Portland General Electric Company

February 6, 1981

Re: Portland General Electric Company et al.
(Trojan Nuclear Plant) Docket No. 50-344
(Control Building Proceeding)

NRC Questions (10/2/79)

FIGURE I-1

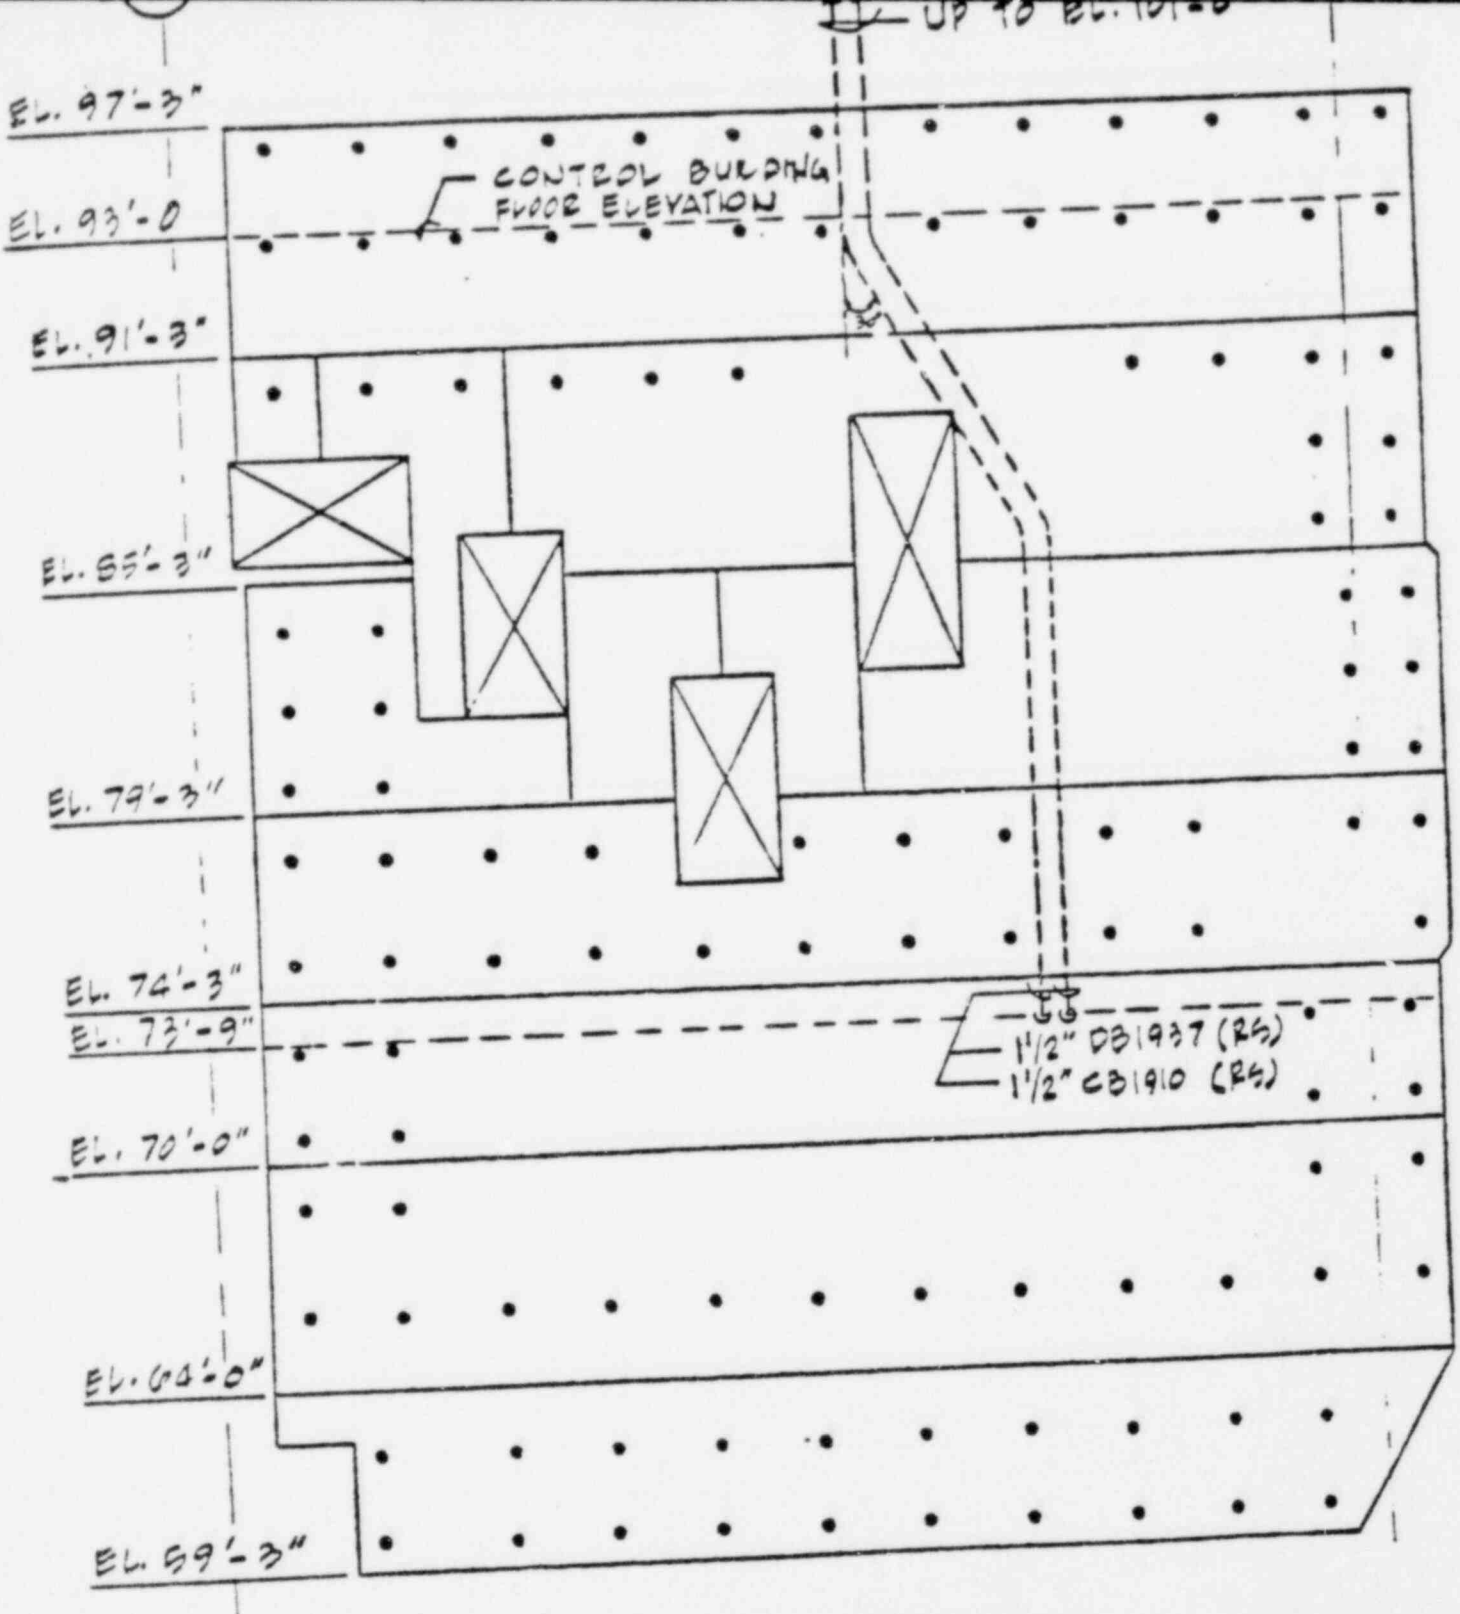
- b. There are no electrical conduits embedded in the N line wall where drilling will be performed. There are two electrical conduits embedded in the R line wall where core drilling will be performed. Their approximate location will be marked on the surface of the walls where the core drilling will be performed. This procedure should reduce the possibility of the drill bit striking the conduit; however, experience has shown that should the drill bit strike the conduit, the enclosed cable would not be harmed. The conduit is made of steel and has a wall thickness of 0.145 inches (slightly larger than $1/8$ of an inch).

Previous observations with regard to the effect of the drill bit striking reinforcing steel has shown that the smaller diameter reinforcing steel would only be nicked by a maximum of 1/8 inch before the drill operator, upon detecting he had struck the steel, could pull back the drill bit. Since the conduit diameter (1-1/2" nominal rigid steel) is much larger than the 5/8" diameter reinforcing bar discussed above, the depth of penetration into the conduit wall before the drill operator detects that he has contacted conduit should be much less due to the larger surface area presented.

Nevertheless, as added assurance that there is no significant safety concern, we have further reviewed the consequences of the encased wiring being completely cut. Our review has shown that two existing conduits, CB1910 and DB1937, are routed in the Control Building from the Electrical Auxiliaries Room (el. 65') to the Control Room (el. 93'). The major portion of these conduits is embedded in the Control Building wall as shown on the attached Figure 1-1.

Nuclear Instrumentation Cabinets C31C and C31D contain redundant safety-related circuitry for the ex-core neutron power range flux detectors (Channels A and B are not affected). The Channel D Cabinet C31D contains additional circuitry that consists of the power range neutron flux comparator circuit, source range neutron flux rate circuitry, and an audio display of the source range flux levels. These two NIS cabinets and their associated electrical circuitry generate the following reactor trip signals:

The loss of Channel C power range detector would not cause a reactor trip since the reactor trip logic (2 out of 4) would not be satisfied. Activation of Control Room alarms (power range loss of detector voltage, NIS high neutron flux power range, and power range comparator deviation) would result from damage to conduit CB1910. Loss of NIS

The effect of damage to conduit DB1937 would be the same as for CB1910 except that Channel D NIS would be involved and the startup rate count meters on the main control board would be lost.

If both conduits CB1910 and DB1937 were damaged, a reactor trip may occur since two of the four NIS channels are affected.

TYPICAL EXAMPLES

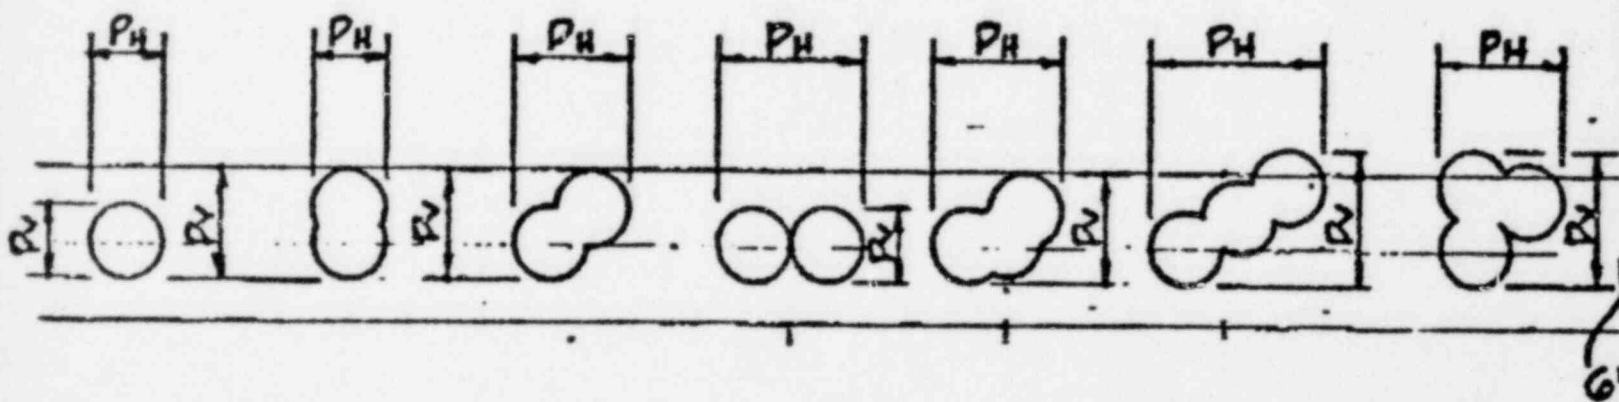
As a further clarification of Spec. C-501, please find below the ground-rules for drilling bolt holes in the Control Building R & N wall, above elevation 65'-0":

Hole: A void resulting from material removed with a core drill from the wall. A hole filled with grout (or bolt and grout) that has attained 5000 psi, shall not be considered a hole as defined above.

Hole Projection: See sketch below.

- a. The hole projection shall not be larger than 7.5 inches.
- b. The sum of the horizontal projections of the holes in a horizontal band shall not exceed 67 inches.

- c. The sum of the vertical projections of the holes in a vertical band shall not exceed 45 inches.
